25 September 2017

**Submission: State Significant Infrastructure Application (SSI 6878) Yallah to Oak Flats
Princes Motorway Extension (Albion Park Rail Bypass) – Submission and Preferred
Infrastructure Report (SPIR)**

Attachment 2 – SCC Revised Alternative Option for Central Interchange

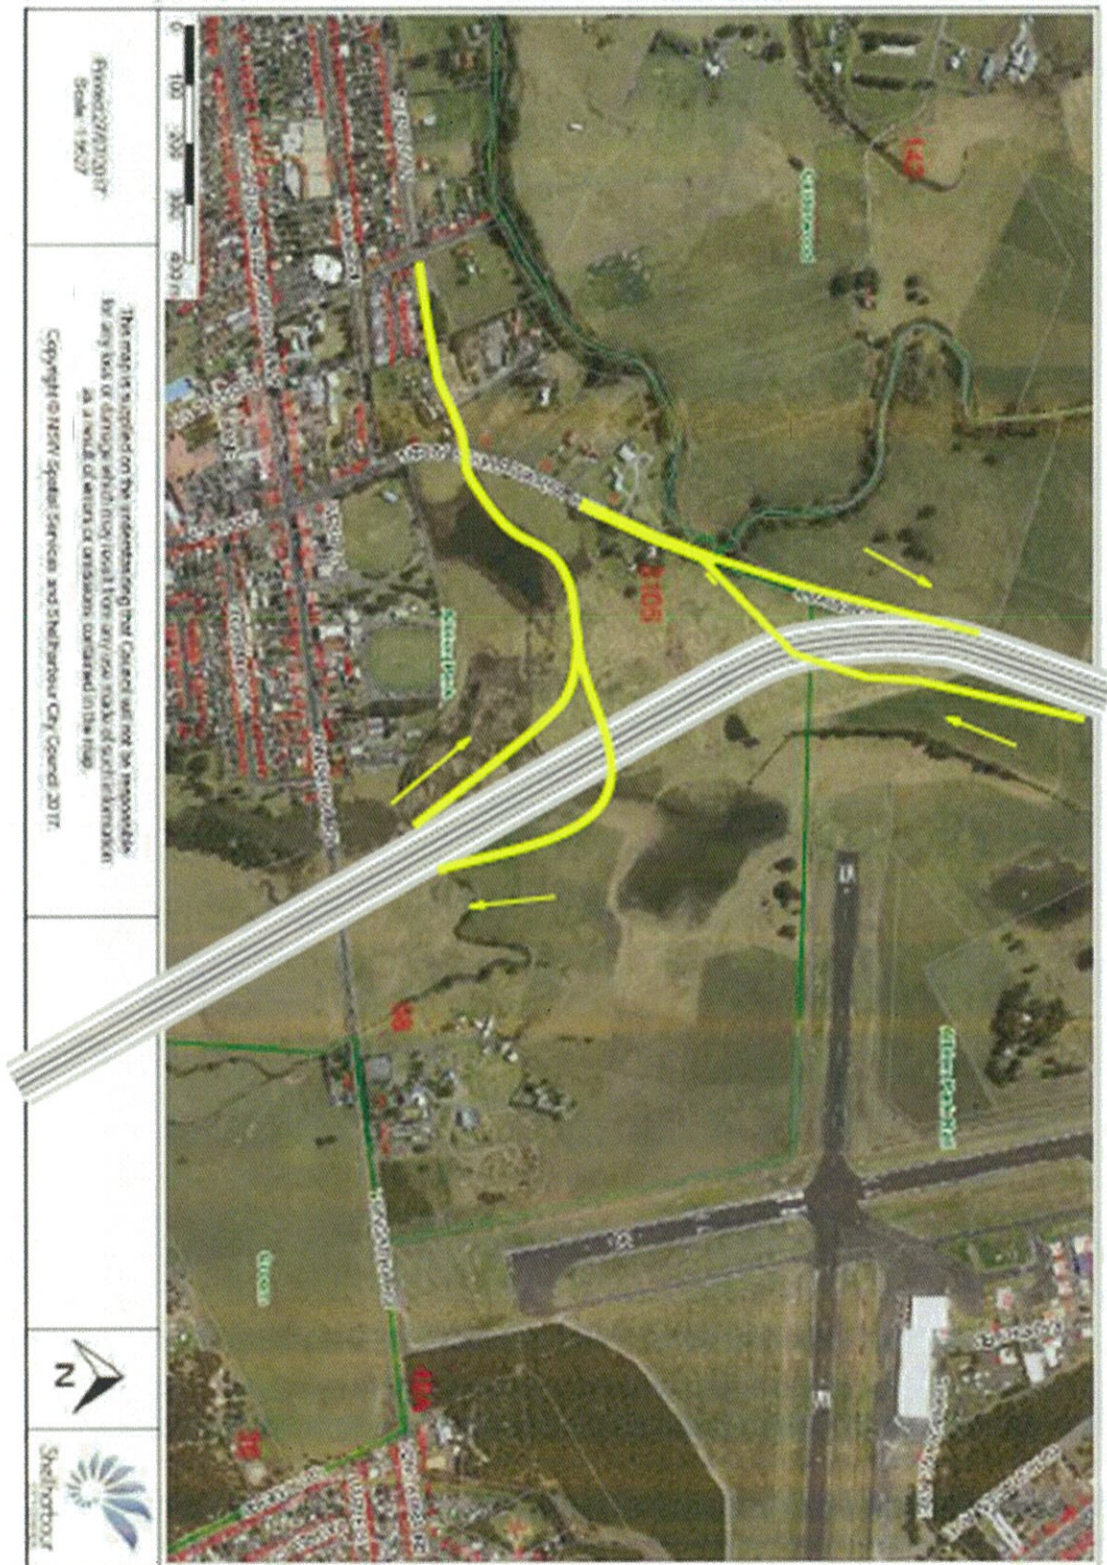
Council has also identified a revised alternative option for the Albion Park Interchange that it considers worthy of further investigation by RMS prior to determination of the SSI application (**Attachment 2**). This option would address the current “decoupling” of the Tripoli Way Extension with the M1 Extension, thereby, giving a better outcome to the travelling public and Albion Park Town Centre. This option requires specific modelling by RMS’s consultant to confirm that it would indeed deliver Traffic Management outcomes, in particular the improved amenity to Albion Park Town Centre. This alternative option may also enable Council to collaborate on the RMS Design and Construction (D&C) contract tender outcomes, thereby allowing for savings to be realised. This Council suggested option for the interchange is very similar to that shown in the original EIS, however, it eliminates the dangerous “weave” and maximises efficiency.

Council has put an earlier version of this conceptual design to the RMS but it was dismissed as being an option not worthy of further consideration at the same meeting in which it was put, without any specific modelling, analysis or further discussion of that option.

The north bound off and southbound on ramps have been relocated further south and serviced by an extension of Tripoli Way to create a four way intersection at the Illawarra Highway. The intersection would be traffic signal controlled with two approach lanes on each leg. The signals would operate on a three phase cycle, similar to the existing intersection of Tongarra Road and Terry Street.
